CITY PLANNING DEPARTMENT

Memorandum – Unified Development Review

To: City Plan Commission
From: Brianna L. Valcourt, M.Arch; Senior Planner
Date: October 26, 2026
RE: "**1489 Pippin Orchard Road"** – Minor Subdivision with Zoning Relief

PROPOSED CONDITIONS: SITE PLAN

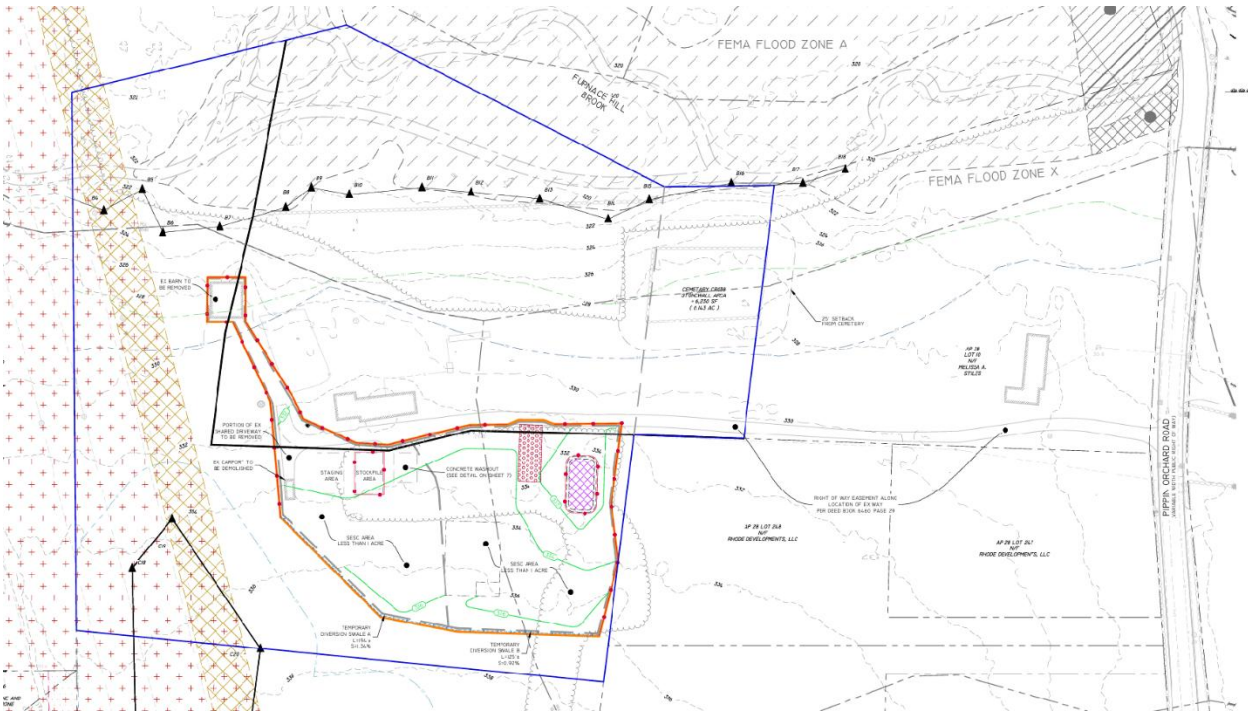
- There is an existing right of way easement adjacent to the easterly side of AP 28 Lot 31 where the existing driveway for AP 28 Lot 31 will remain. The existing driveway for the single-family dwelling

located at 1489 Pippin Orchard Road is proposed as a shared access drive to the existing and new development.
- A new 12-foot-wide private driveway is proposed to extend from the existing shared access drive to the proposed dwelling on Lot 1.
- No new public roadway or improvements to the existing access driveway are proposed.

- Stormwater management rain gardens are shown on the proposed plan for the new impervious roof areas.
        - RIDEM's natural heritage map shows that there are no known rare species or sensitive habitats located on or near the site.
